REQUEST

Current Zoning: R-3 (single family residential)
Proposed Zoning: R-8MF(CD) (multi-family residential, conditional)

The petition proposes to allow up to 130 townhouse style dwelling units for a density of 5.7 dwelling units per acre on vacant land.

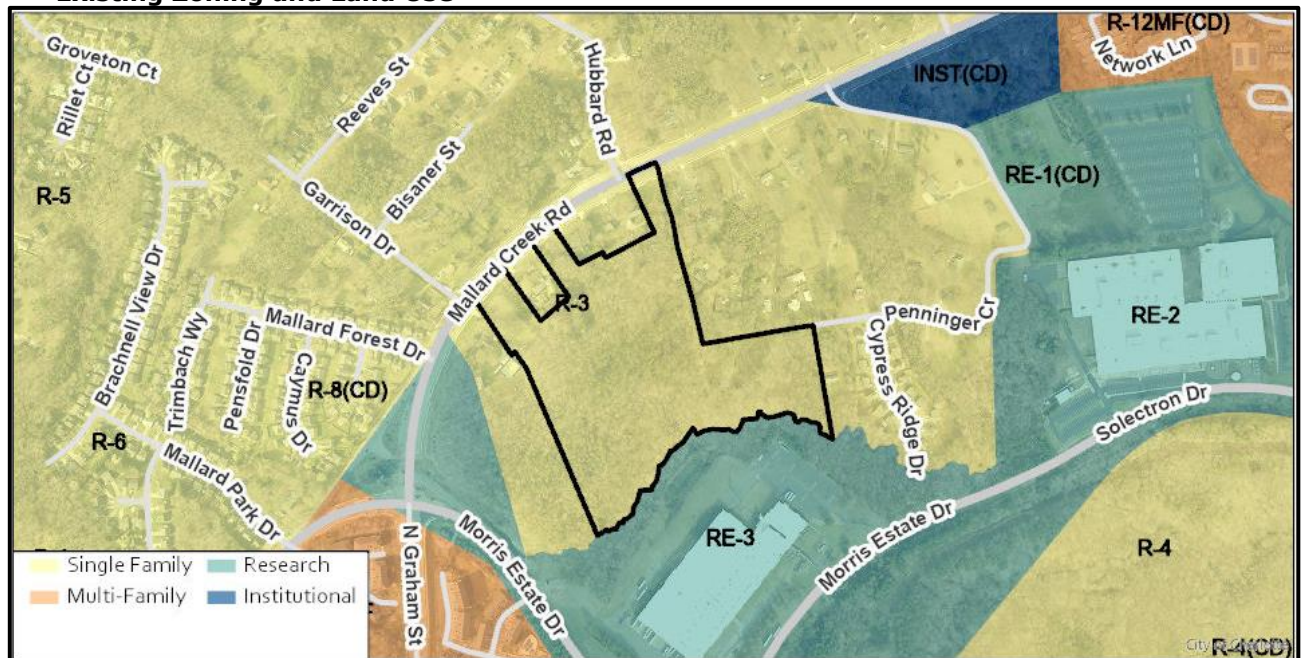
- Allows up to 130 for sale townhome units.
- Commits to constructing road improvements within the existing unmaintained Penninger Circle public right-of-way.

- Commits to not extending Penninger Circle to Mallard Creek and is shown as a street stub.
- Provides a right-in and right-out only on Mallard Creek Road with 100-feet of storage.

- Provides a planting strip and sidewalk along all streets.
- Provides a 50-foot Class C buffer to abutting single family residential areas.
- Architectural standards include:

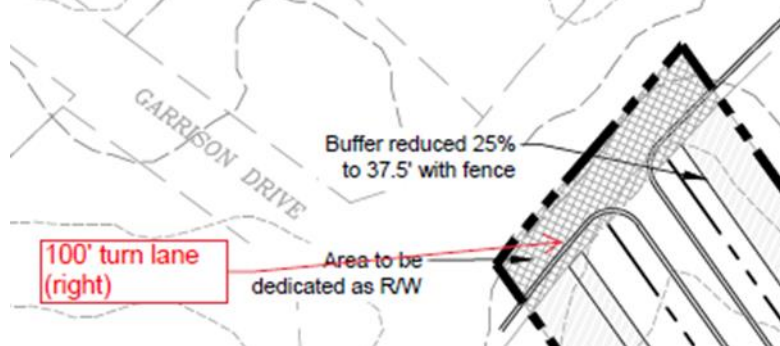
1. The petitioner should revise the site plan to include the roadway improvements that will be constructed within NCDOT's STIP (#U-2507A). In accordance with Charlotte BIKES, please provide an 8-foot planting strip and a 12-foot multi-use path, if sidewalk is not constructed within the STIP.
2. The petitioner should revise the site plan and conditional note(s) to confirm adequate intersection sight distance, according to CDOT's Sight Distance Policy, for access proposed on Mallard Creek Road.

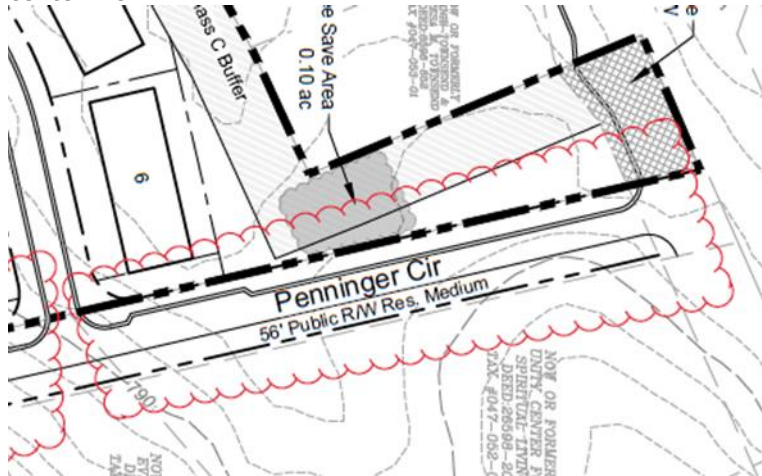
3. Technical Clarification (site plan dated 09/14/20) The petitioner should clarify conditional note (Section 3.G.) that 2-ft of additional right-of-way should be dedicated from back of the 12-ft multi-use path. The petitioner should construct a 12-ft multi-use path where the existing sidewalk is removed for the proposed right-turn lane. Where the existing sidewalk remains undisturbed along the property frontage, CDOT requests for the existing sidewalk to be widened to 12-ft, in accordance with Charlotte BIKES.

4. Technical Clarification (site plan dated 09/14/20) The petitioner should clarify whether front-loaded or rear-loaded units are proposed. If front-loaded, the petitioner should commit to pair shared driveway aprons with every two units, to preserve the proposed planting strip and sidewalk within the public right of way. This request limits the number of curb cuts, and promotes walkability, and preserves a quality streetscape.

5. Technical Clarification (site plan dated 09/14/20) The petitioner should clarify conditional note (Section 3.D.) that a proposed right-turn lane will be constructed at the proposed Mallard Creek Road right-in/right-out access. The proposed right-turn lane should have 100 linear feet of storage with the appropriate bay taper length, according to NCDOT design standards.

6. Technical Clarification (site plan dated 09/14/20) The petitioner should clarify the site plan to show and call-out the existing Penninger Circle private drive that ties into existing Mallard Creek Road. CDOT requests the petitioner to clarify that the existing Penninger Circle road improvements will be constructed in accordance with CLDSM U-02 - Local Residential Medium Section cross section design standards, on both sides of the existing Penninger Circle road centerline.
